# Essential facts of the situation – Overall Plan

# Essential facts of the situation- Purported Engineering as-built

## SIERRA RANCH PRESERVE AREA AS-BUILT TOWN OF DAVIE, FL.

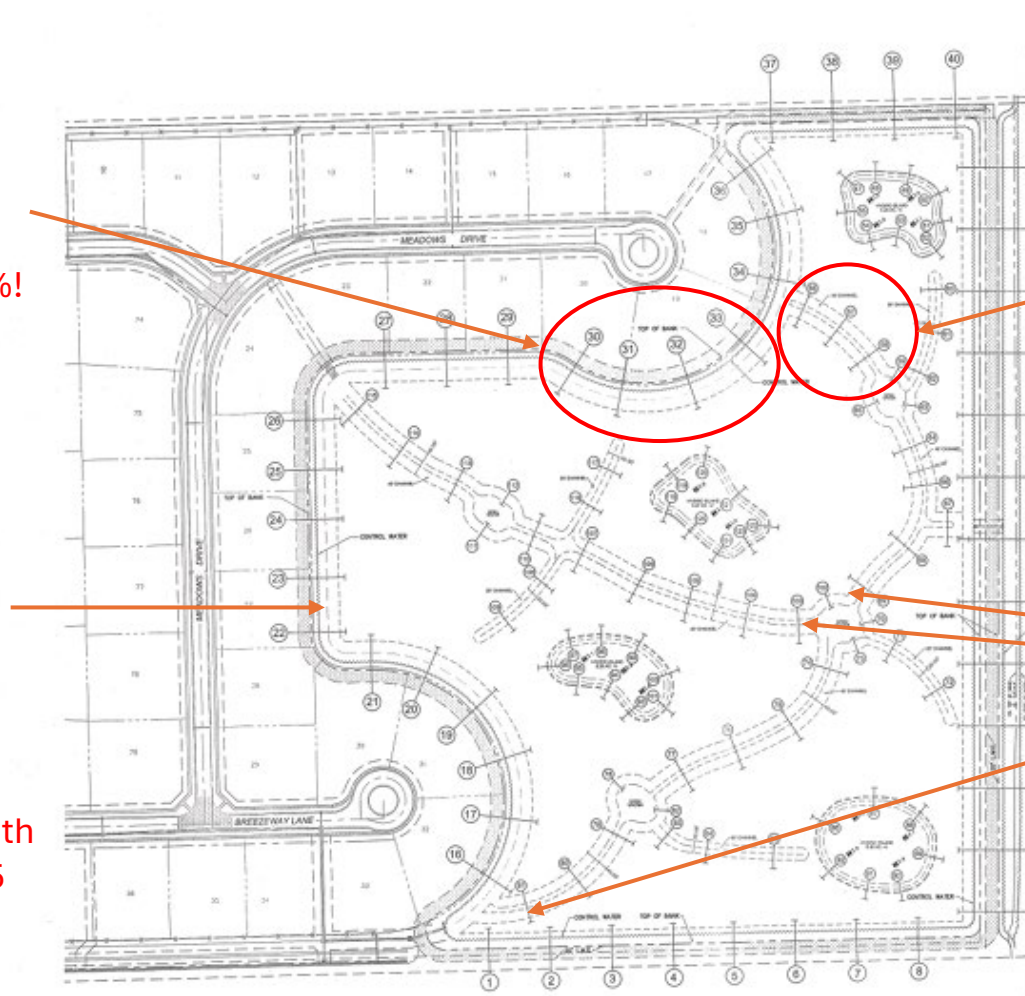
Width measurements between purported as-builts and Broward County Property Appraiser aerials show deviations of as much as 79%!

This 40 foot wide 10 foot deep section does not exist as clearly visible from Broward County Property Appraiser aerials!

How can 10 foot deep channels shallow so much in just 2-3 years?  
Or were they ever cut to the purported depth in the as-builts?

No hydric berm to prevent sloughing and contain marsh species in designated areas

Not erosion resistant

This was engineered to the wrong depth contrary to both the environmental plan per SFWMD permit and 10 foot minimum depth CBWCD drainage district depth regulation! 10 foot minimum depth excavation results in open water width being minimum 46 feet instead of 35 feet in plans due to CBWCD grading rules

# Date and Signature Tampering on the CBWCD version

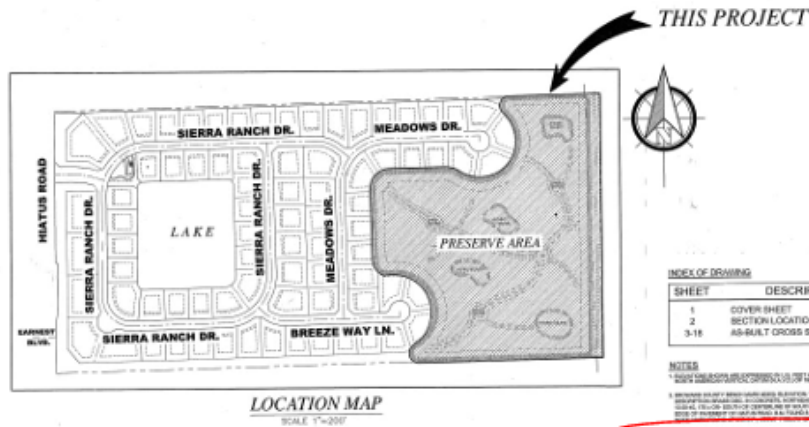
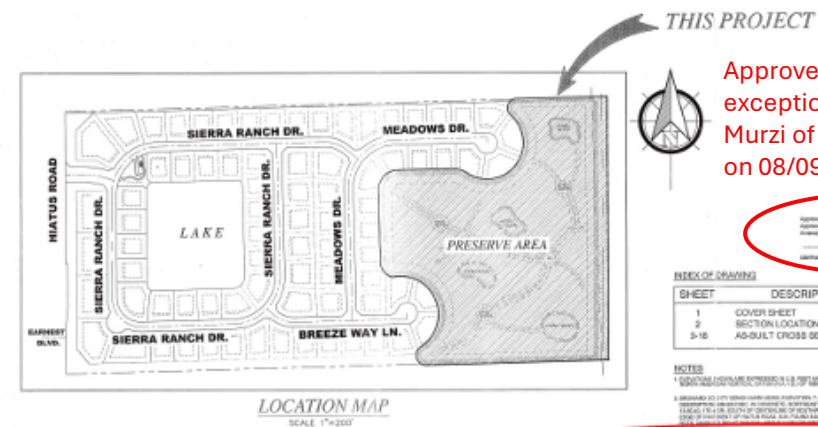
1. Both are identical in contents confirmed by Pillar Consultants
2. Joseph Martin Surveyor signed the SFWMD version on 12/10/2021 and the CBWCD version on 07/25/2023
3. Chad Edwards PE signed the SFWMD version on 10/27/2022 and the CBWCD version on 08/16/2023 after the as built approval by the CBWCD on 08/09/2023

Not valid without signature and original raised seal of surveyor! Where is the raised seal on the CBWCD version?
